August 24, 2022

Re: Inspection Letter: HHF005 Spec Lot 5 Homestead at Hook Farms 1st Plat – 2022 SW Farm Field Ln., Lee's Summit, Missouri

Vista Structural Engineering, LLC was asked to address the following rough-in inspection items for the project located at above referenced address. Please see the following responses w/ attached partial plan mark up, calculations, and site photos for reference.

Item #1

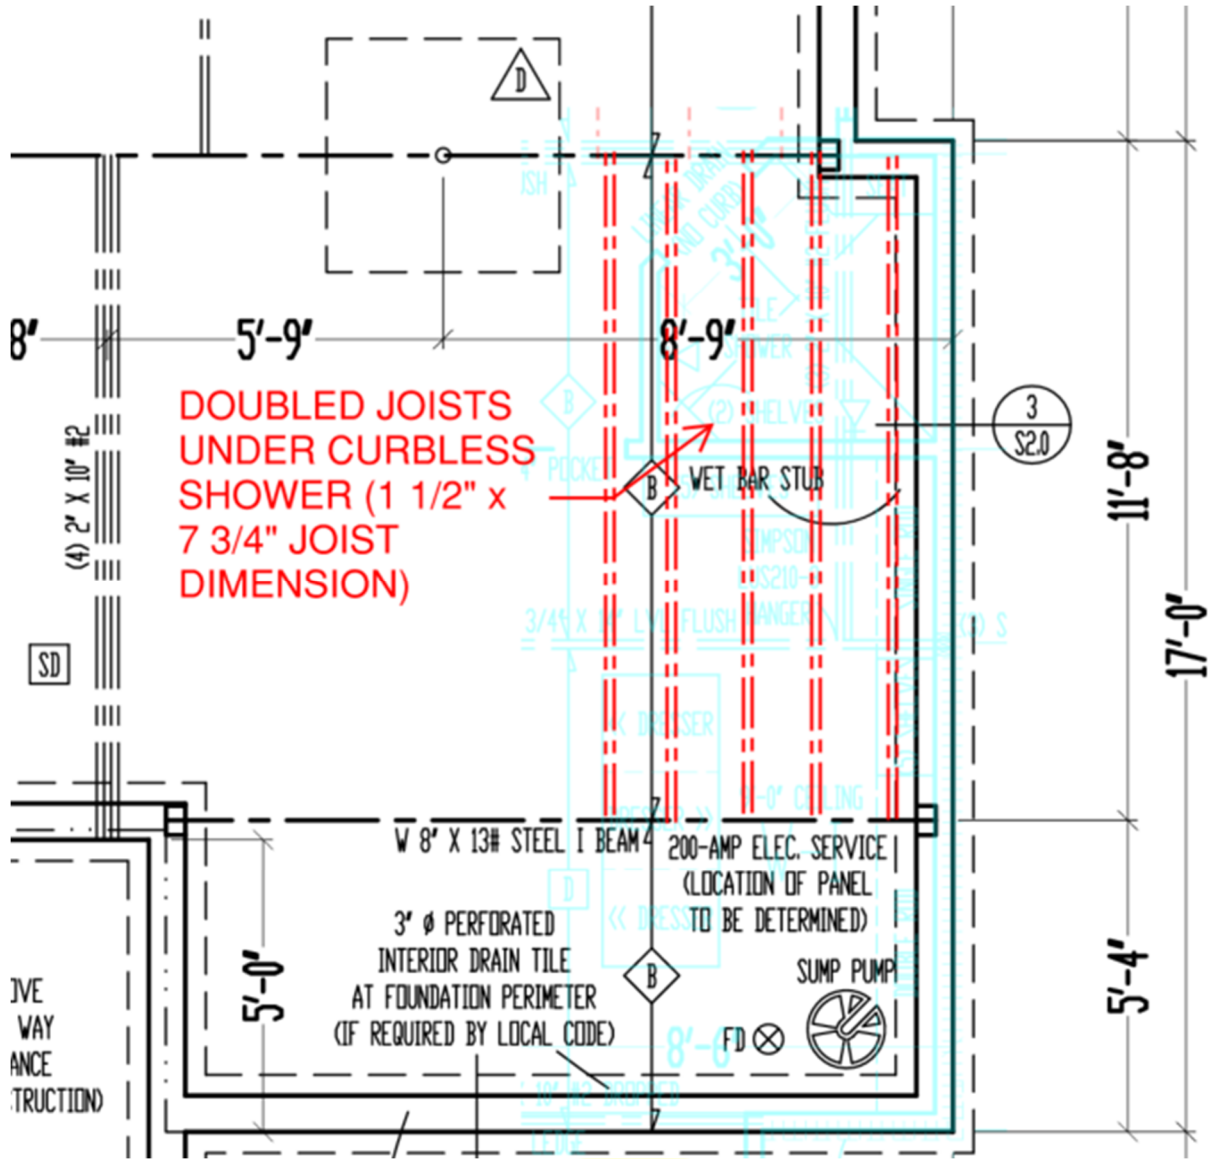
1) **Inspection comment: Address rafter to ceiling joist connection above front entry.**

Vista Structural's response: *We recommend installing a 0.22" x 6"-long Simpson SDWS screw up through the top plate, into the bottom of each ceiling joist. The ceiling joists should then be connected to the rafters with a 2x4 fastened to both the ceiling joist and rafter with (2) 10d nails into each. This will provide a complete path of resistance to design uplift forces*

Item #2

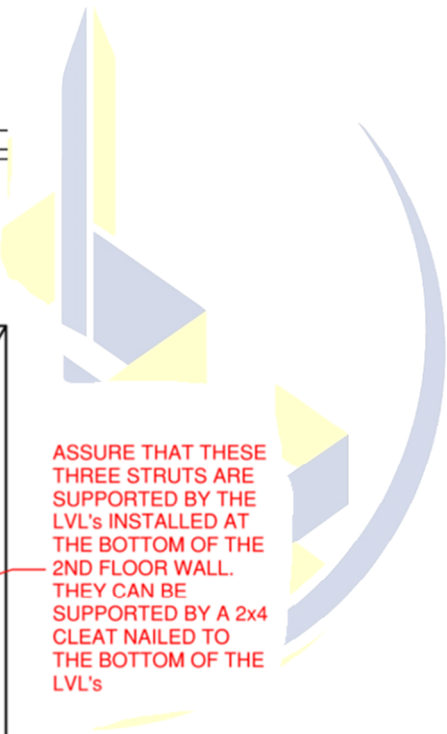
2) **Inspection comment: Address rafter landing on blocks at 2nd floor.**

Vista Structural's response: *We recommend installing Simpson SDWS22600DB-R50 screws, to be driven up through the plates and into the bottom of each of the rafters. The ceiling joists should be fastened to the rafters with a minimum of (2) 10d nails. This will provide a complete path of resistance to design uplift forces.*

Item #3

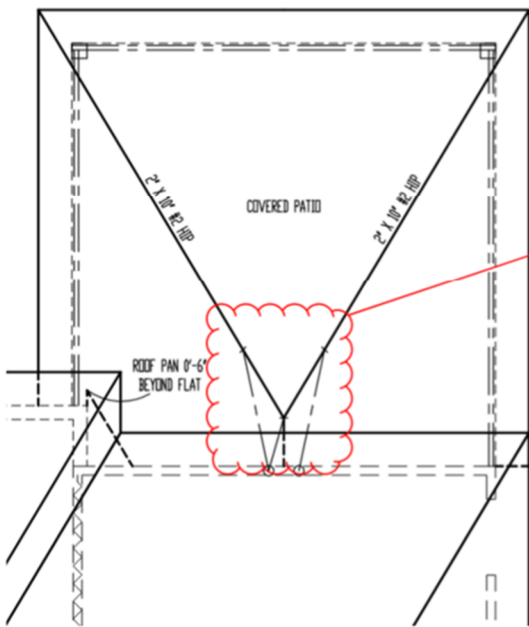
3) **Inspection comment: Address over-notched ceiling joists and rafter bearing at bed 2/3 bath.**

Vista Structural's response: *We recommend furring out the wall to provide an additional 1 ½" of bearing for rafters and ceiling joists by installing a 2x10 fastened to each stud with a minimum of (3) 10d nails. Picture of completed work attached.*

Item #5

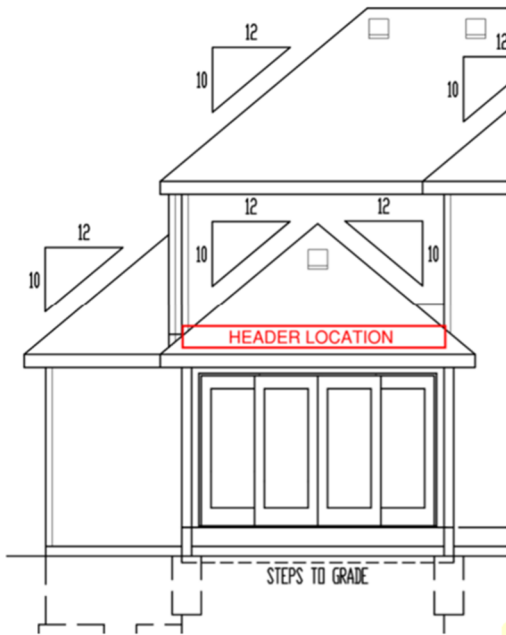
5) **Address notched LVL header above rear slider.**

ASSURE THAT THESE THREE STRUTS ARE SUPPORTED BY THE LVL'S INSTALLED AT THE BOTTOM OF THE 2ND FLOOR WALL. THEY CAN BE SUPPORTED BY A 2x4 CLEAT NAILED TO THE BOTTOM OF THE LVL'S

Vista Structural's response: *Since the ceiling joists above the patio and the floor joists above the dining area are spanning parallel to the beam, the loading on the beam is coming from the second floor wall and the roof above this second floor wall. Therefore, it is acceptable to install the LVL beam at the bottom of the second floor wall. The main item that should be verified before city approval is that the struts that are clouded on the partial roof plan attached should be supported by the beam in the second floor wall. These struts can be supported by a cleat fastened to the side of the bottom of the LVL beam.*

DESCRIPTION: joists under zero entry shower

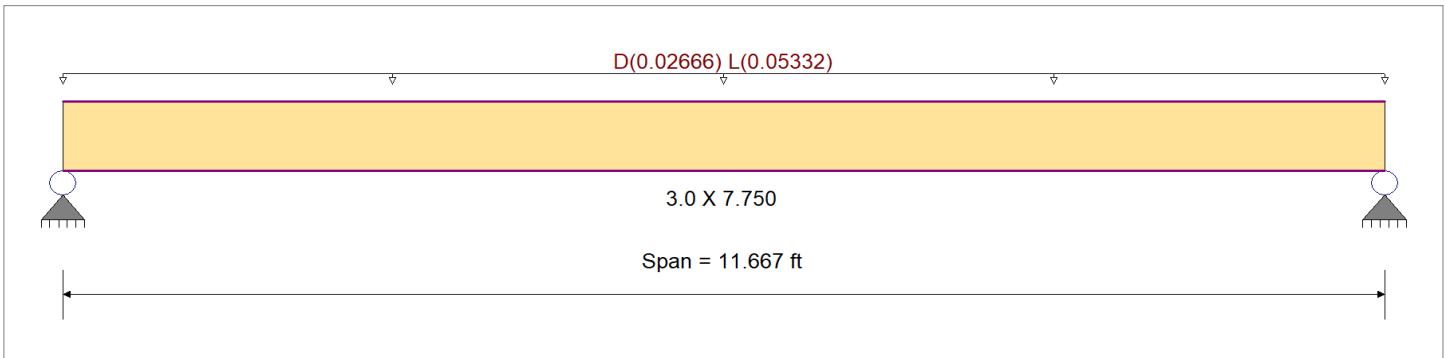
4) **Address over-notched floor joists at master shower.**

Vista Structural's response: *We recommend installing doubled joists under the shower, where the depth of the joists is reduced from 9 ¼" to 7 ¾". A calculation has been attached, showing that doubled 1 ½" x 7 ¾" joists will adequately support design loading.*
